Cylinder Head Change – 135 thru 200

Mariner and Mercury

1993 and newer

Cylinder Head

Figure 1. New Cylinder Head

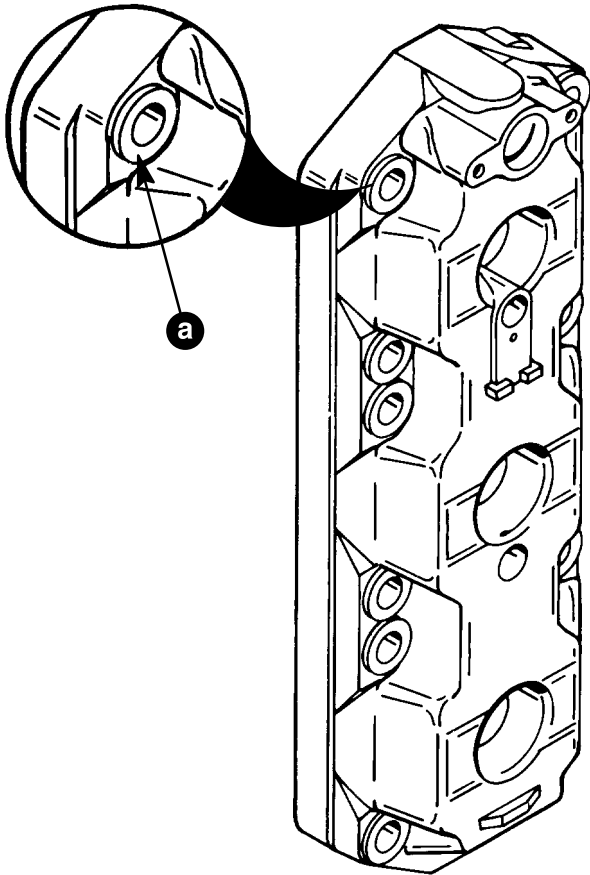
An improved cylinder head is used on the models listed. The improved head has cast-in head bolt washers, torque specifications, and torque sequence. They will back-fit on some outboards. The cast-in washers eliminate the use of flat washers under the cylinder head bolts. The cylinder heads are anodized and painted powerhead black.

a - Cast-in Torque Sequence.

b - Cast-in Head Bolt Torque.

a - Cast-in Material to Eliminate Washers.

IMPORTANT: When the washer is "cast in" the cylinder head, **DO NOT** install a washer under the head of the bolt.

Figure 3. Cylinder Head Bolt

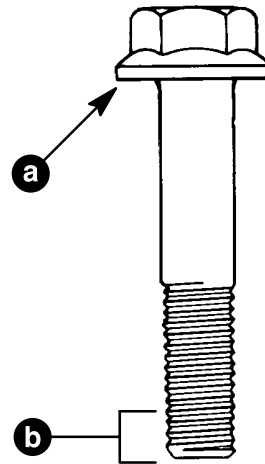
When replacing or installing a cylinder head bolt, apply 10W-30 or 2 cycle oil to the head bolt in the areas shown. The absence of lubrication may result in insufficient clamp load and possible head gasket failure.

a - Oil Under the Washer or Head.

b - Oil First 4 Threads.
